BP # 30033 V RJs

CP 81-4-15
C-3 Zone
[illegible] Fontaine Ave
3 Story Type III 1 hr
Occup. A2.1/B-2
Valuation $400,000
[illegible] = 1163.00 ←
SMIPA = 33.00
[illegible] = 6000.00
[illegible] = 12000.00
$ ~~[illegible]~~
$ [illegible]

INTERIOR ALTERATIONS & ADDITIONS
FOR PIZZA TIME THEATRE, INC.
2445 FONTAINE ROAD, SAN JOSE, CALIFORNIA

SHEET NO.
S-1
OF 2

EXISTING MEZZANINE FLOOR FRAMING PLAN

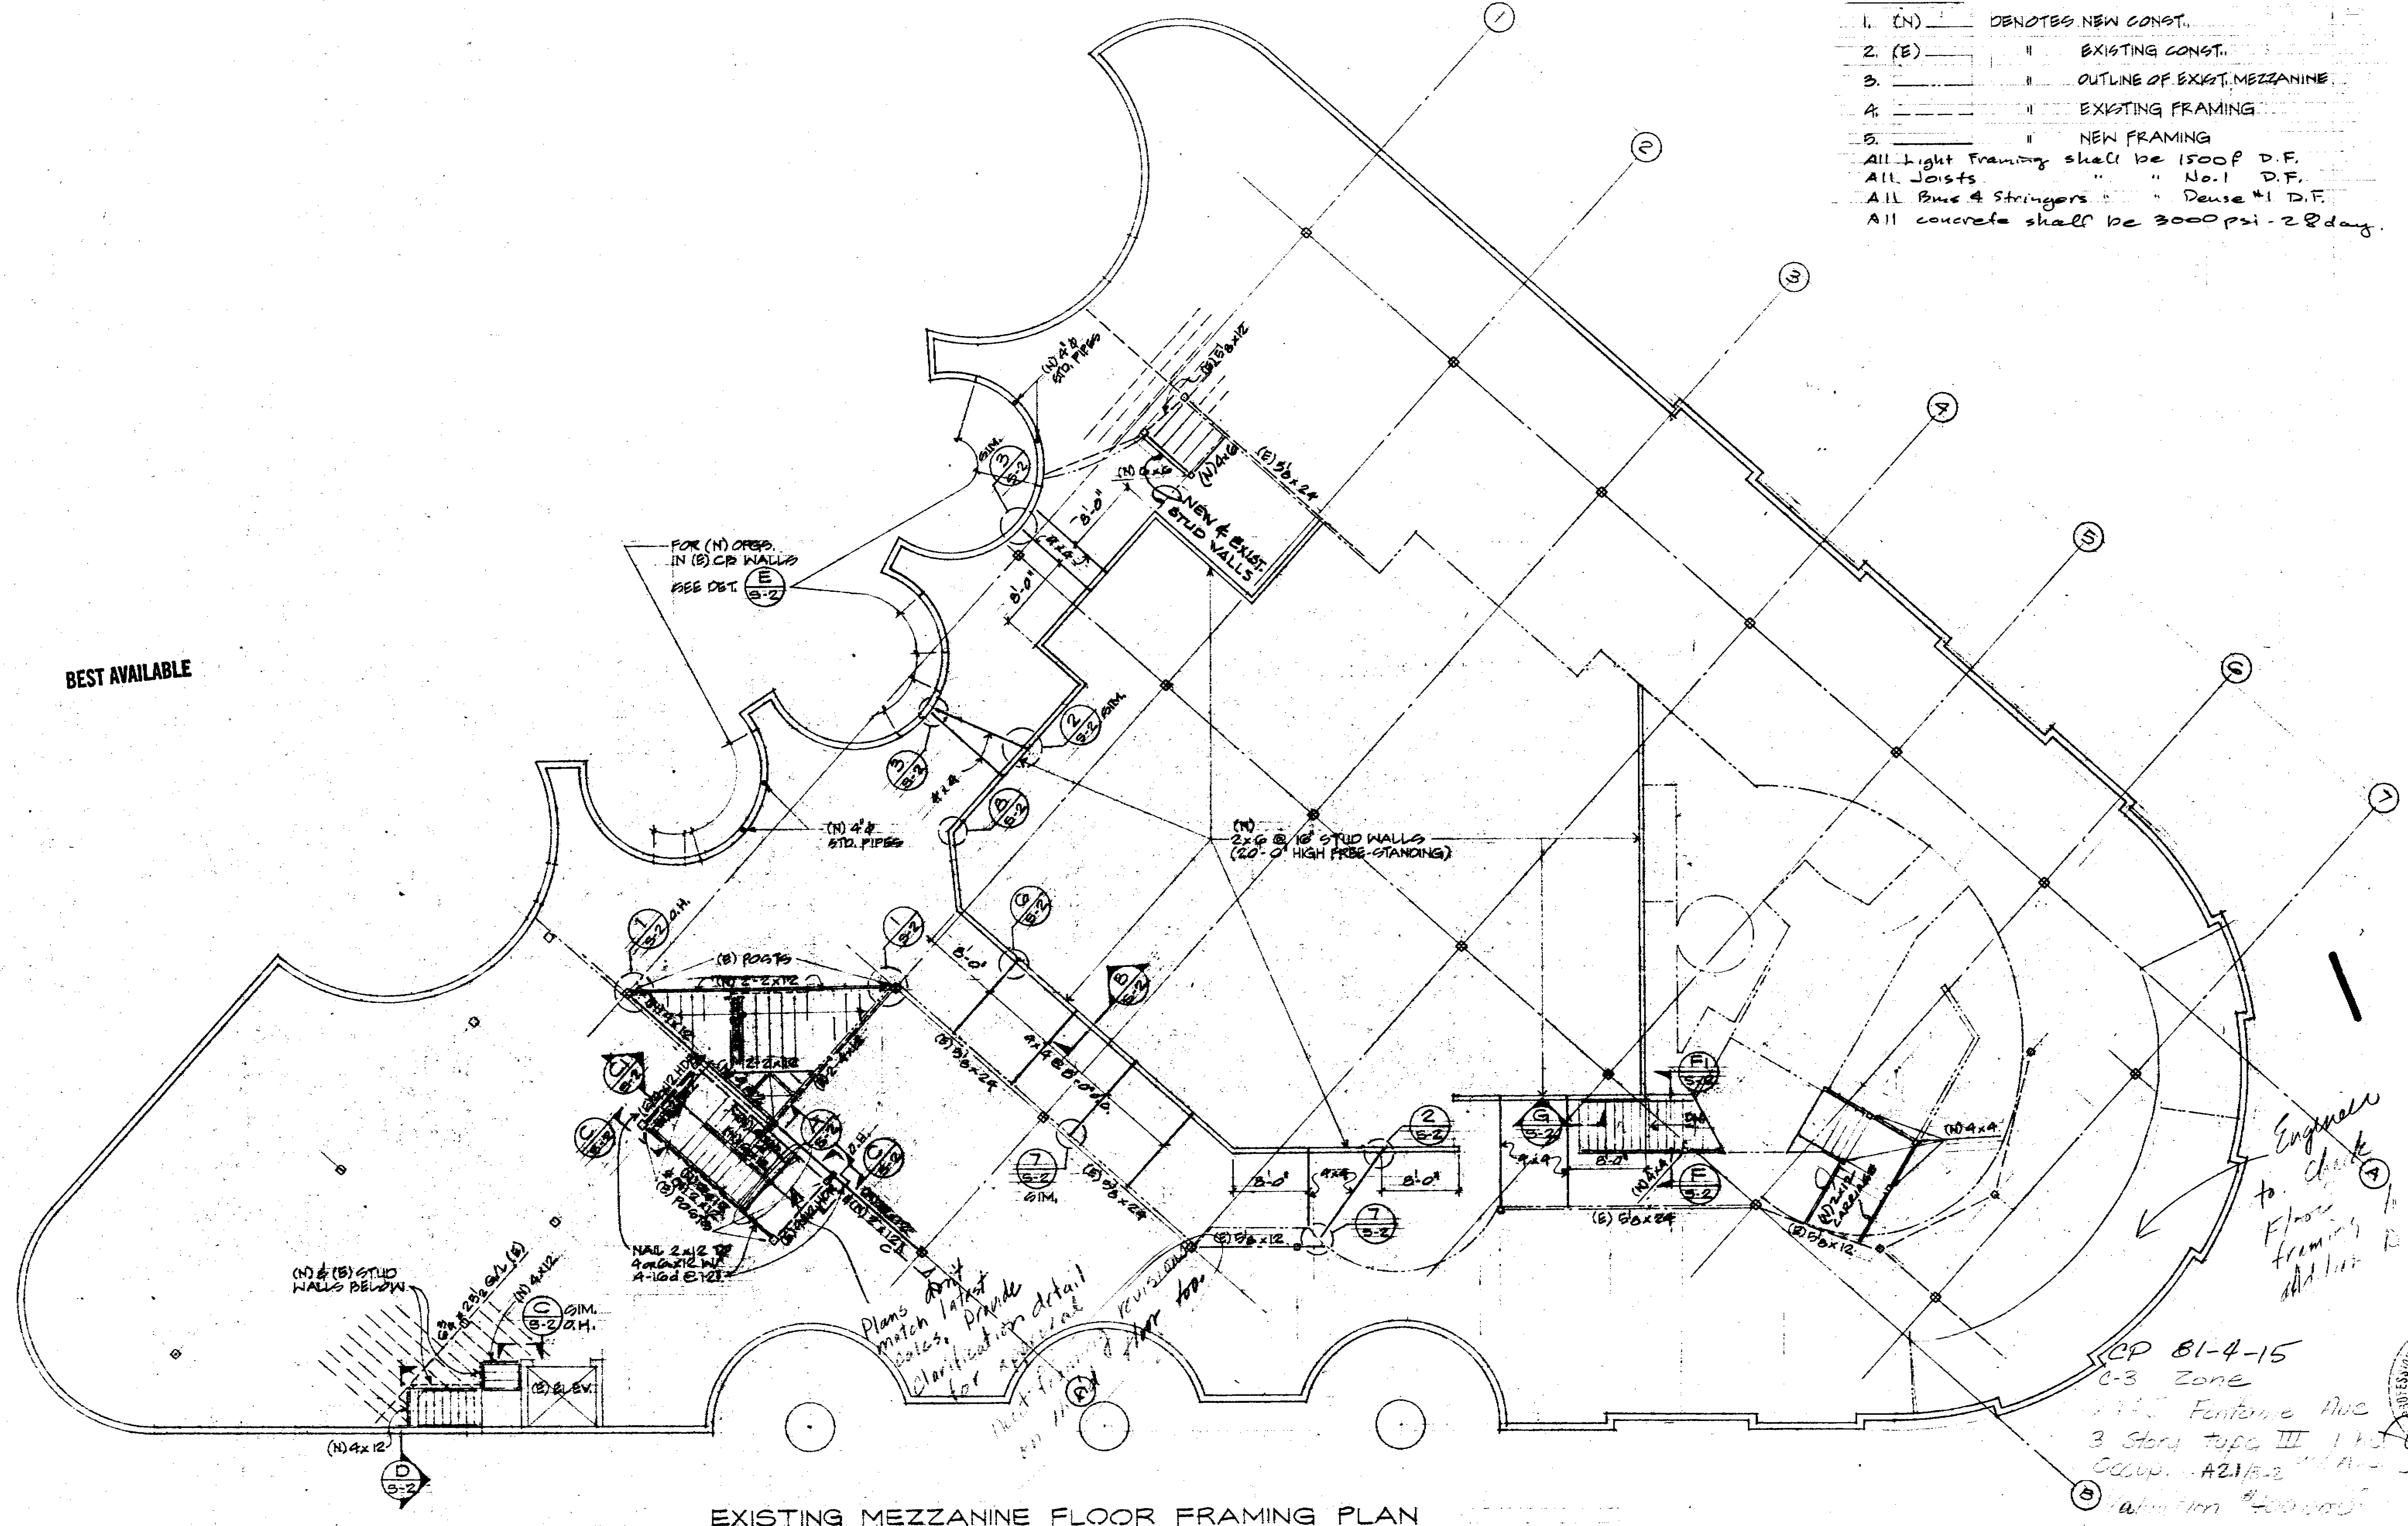
Plans don't match latest calcs. Provide clarification detail for approval

Must [illegible] revision [illegible] floor too

Engineer to check Floor framing addition

SITE PLAN
SCALE 1/16" = 1'-0"

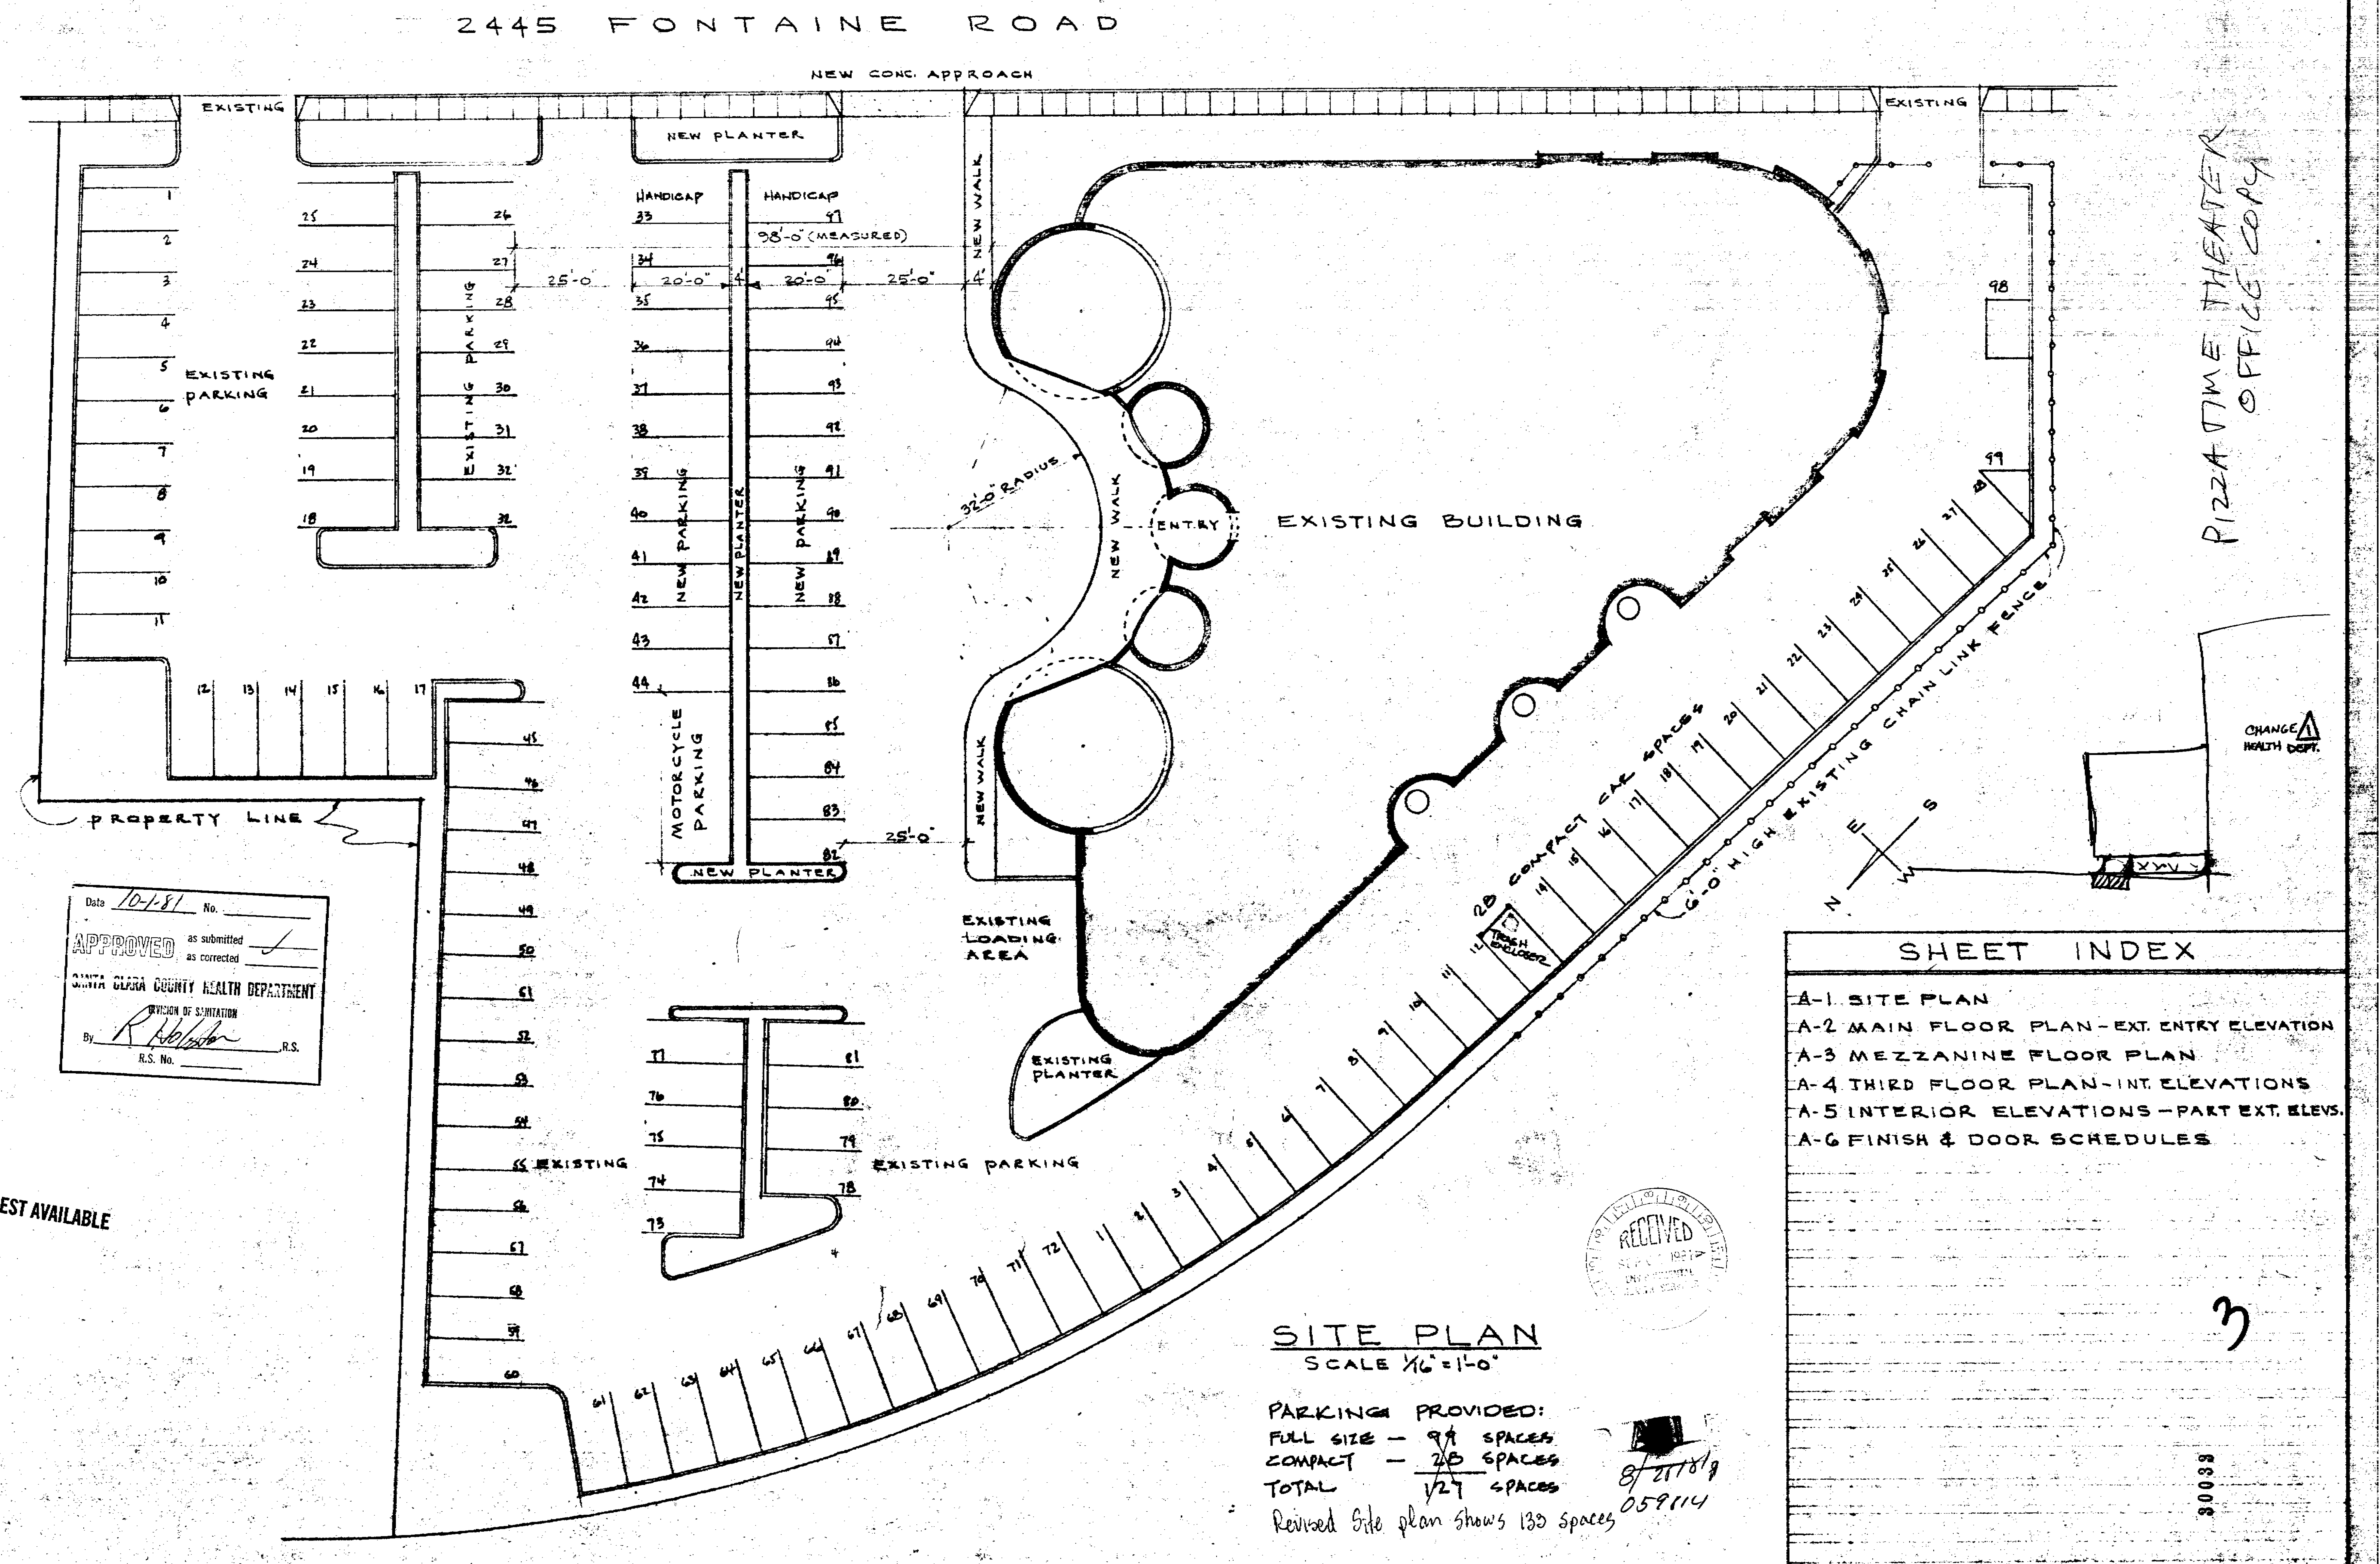
Revised Site plan shows 133 spaces

MEZZANINE FLOOR PLAN
SCALE 1/8" = 1'-0"

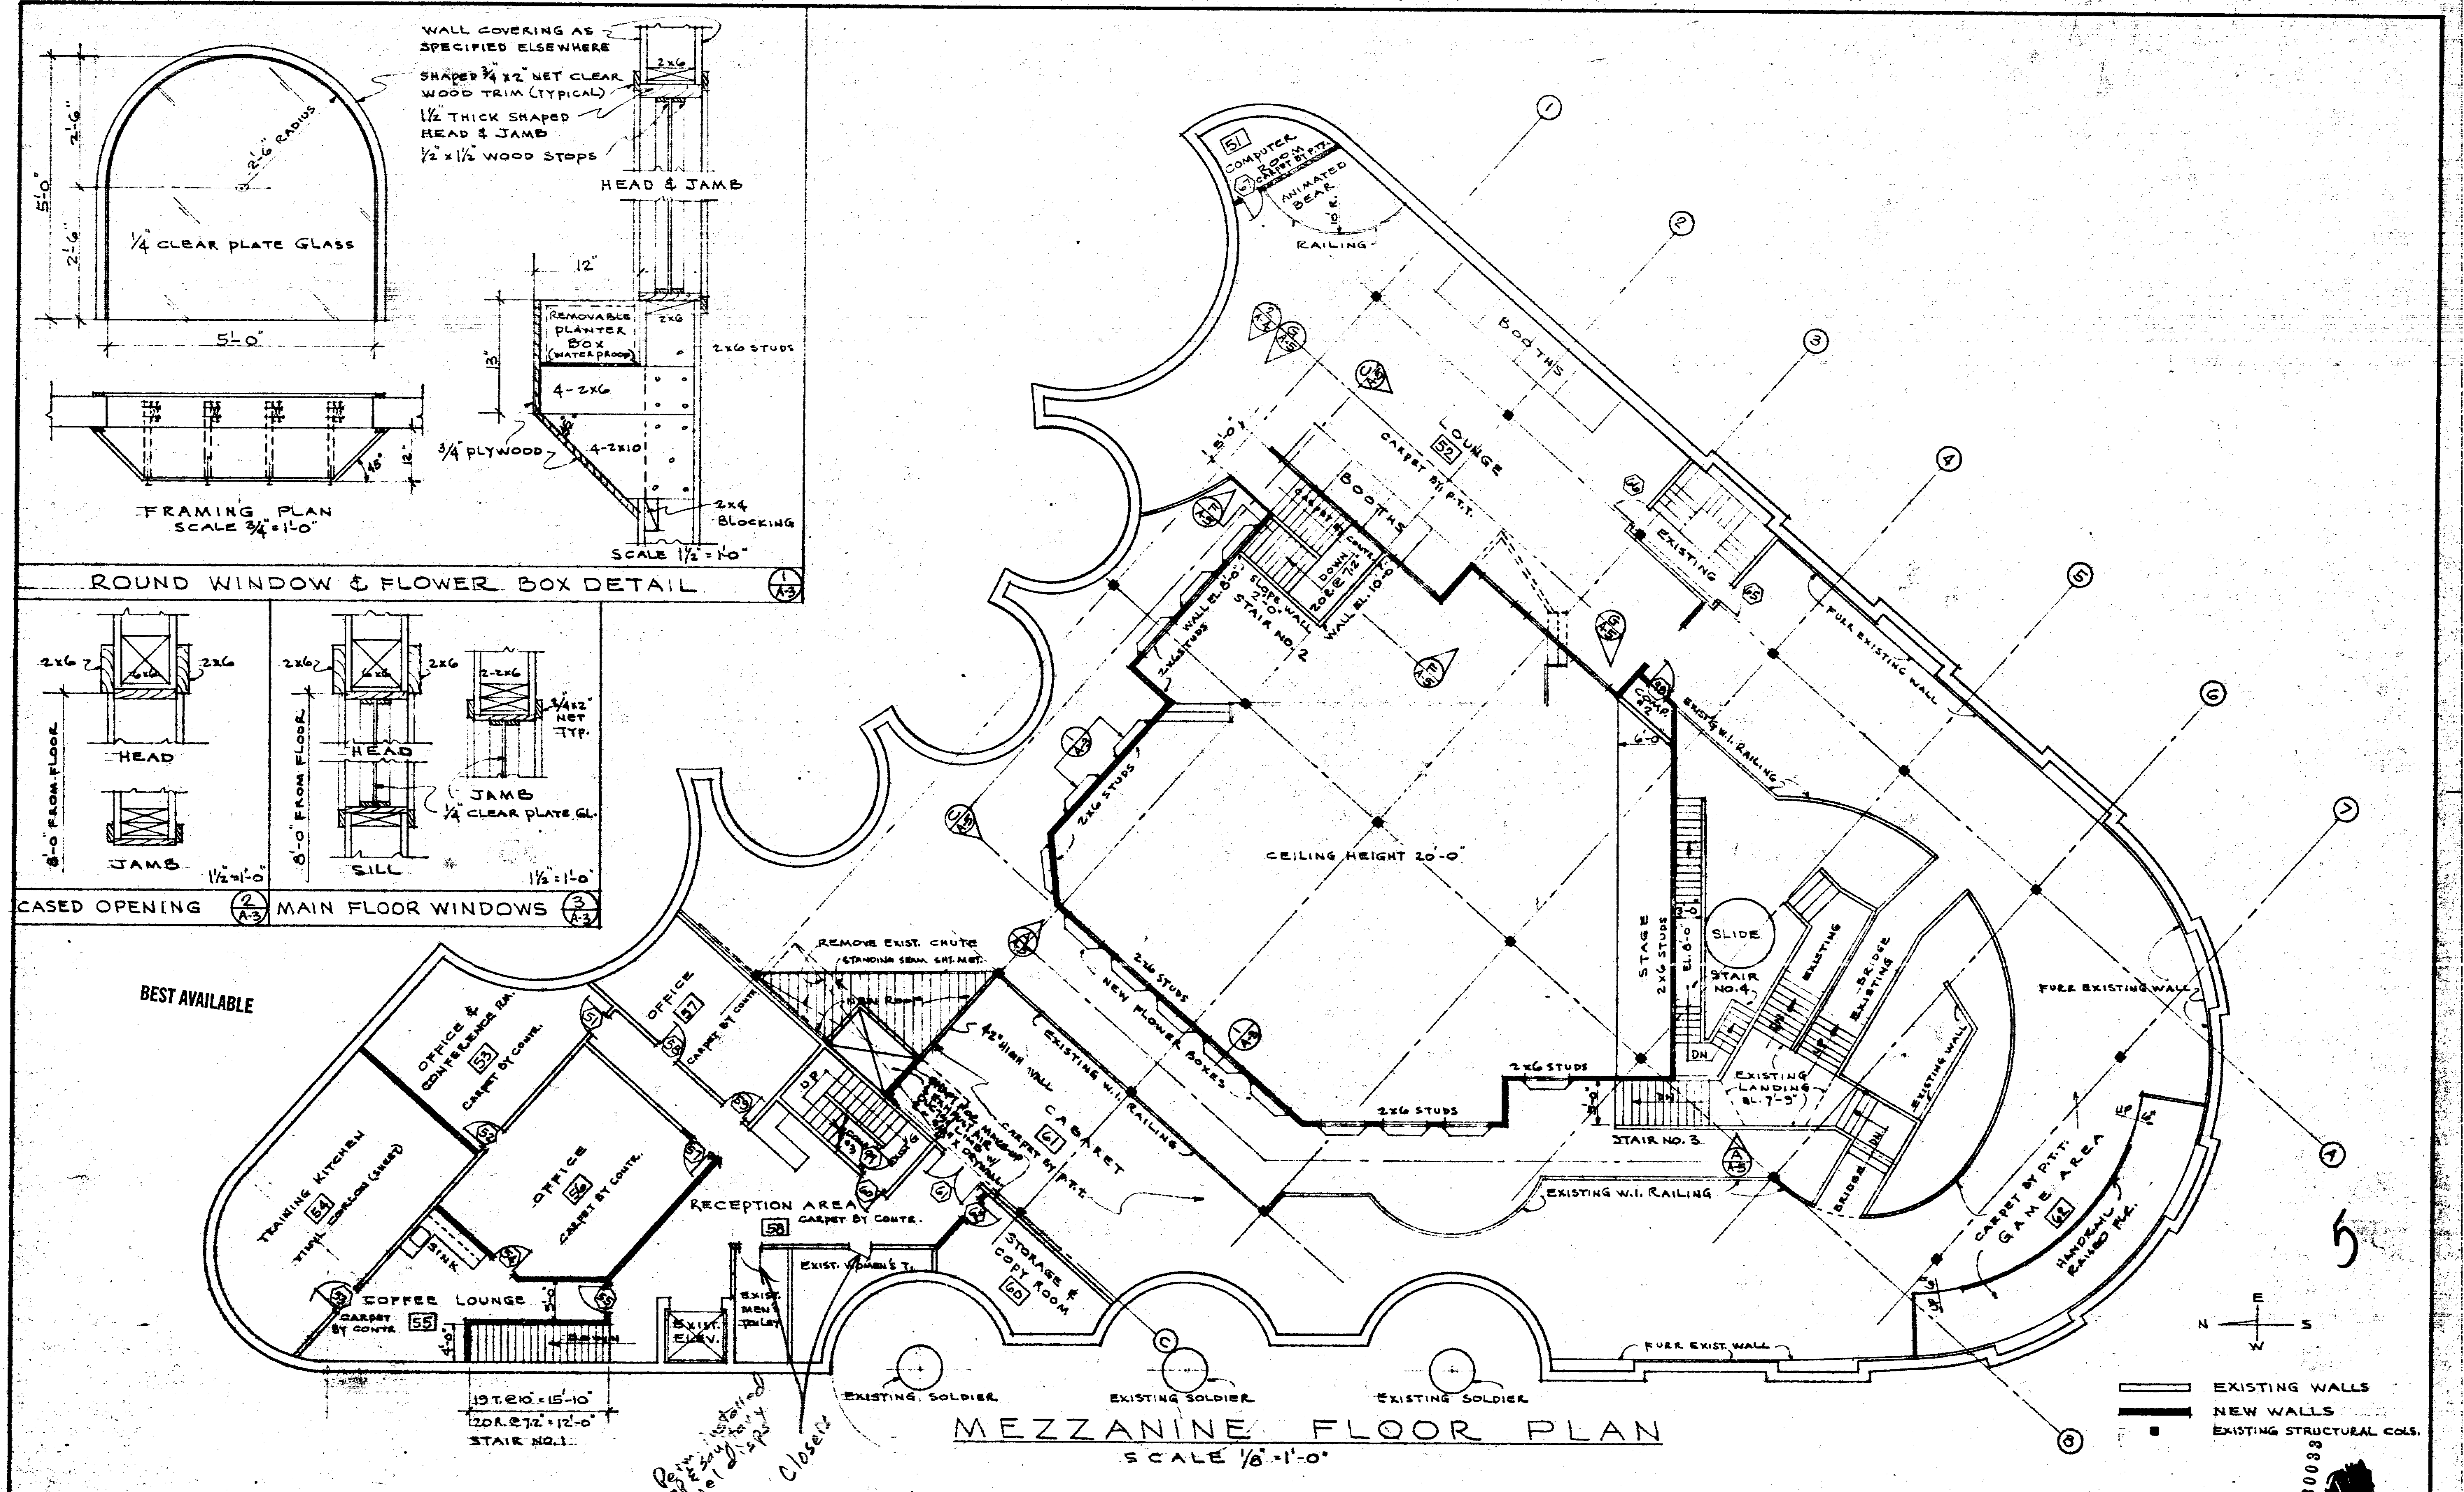
Perm installed soap & sanitary towel disp.

Closers
